Lowpass filter for 5MHz

From: G8MNY@GB7CIP.#32.GBR.EU
 To : TECH@WW

From Brian g3yrh @ GB7BMX

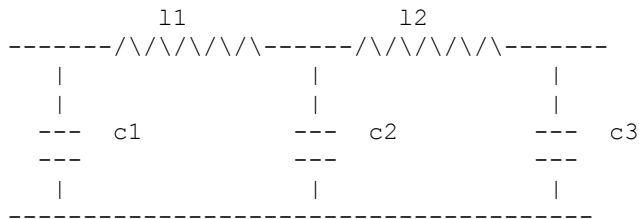
Doing some analysis on a 50Ω source & load, the Ls needs to be about 2uH.
 Excluding losses the response is...

MHz	Loss dB
5	0.1
7.4	3
10	16
15	34

The frequency response figures that you quote based on a 2uH inductor value are in agreement with my own calculations. Unfortunately, though, 17t on a T50-2 toroid does not yield 2uH! The AL figure for this core, taken from the Micrometals web site & other places, is $4.9\text{nH}/N^2$ and this results in an inductance value of 1.42uH for 17t.

Using 1.42uH as the inductor value actually results in a lower input VSWR at 5MHz than 2uH - 1.05:1 compared with 1.1565:1. The cut off frequency, as you would expect, is higher with the -3dB point being at 8.13MHz; the attenuation being 12.1dB at 10MHz & 29.5dB at 15MHz.

If it is felt necessary for the inductance to be increased to 2uH then the number of turns should be increased to 20. Another solution would be to leave the inductors as they are and increase the capacitor values with C1 and C3 becoming 360p and C2 becoming 820p. This would result in the input VSWR being 1.12, the 3dB point being at 7.85 MHz and the 10MHz and 15MHz attenuation figures becoming 13.8dB & 31.1dB.

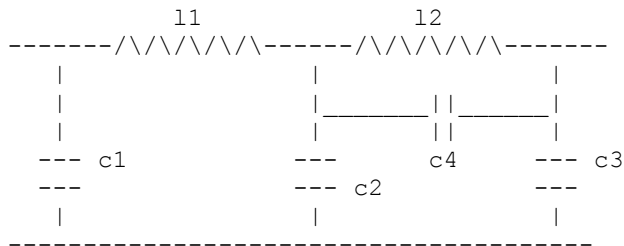
a "M" derived filter should be considered. This is where a capacitor across one of the coils is used to resonate it near 10MHz to improve the rejection.

With L2 = 1.5uH & tuned with a 170pF to 10MHz then response...

MHz	Loss dB
5	0.1
6.6	3
10	>50
15	35

I'm not convinced about the need for a notch in the response characteristic at 10MHz. The attenuation characteristics calculated for the basic filter rely on the load remaining at 50 Ohms independent of frequency. This is not, of course, the usual situation in practice. Assuming that the load is a dipole, the feed impedance will be around 50 Ohms at resonance: at the second harmonic, though, the feed impedance will rise to around 5000 Ohms. This load will be transformed by the feeder but whatever value appears as the filter load, the result will be that would be difficult to transfer any power to the aerial through the filter.

Apart from anything else, the 100:1 VSWR would cause the feeder losses to rise significantly. So even if some second harmonic were to 'escape' the filter, very little would actually reach the aerial - assuming 100ft of UR67, the attenuation of the second harmonic resulting from feeder loss alone would be around 9dB.
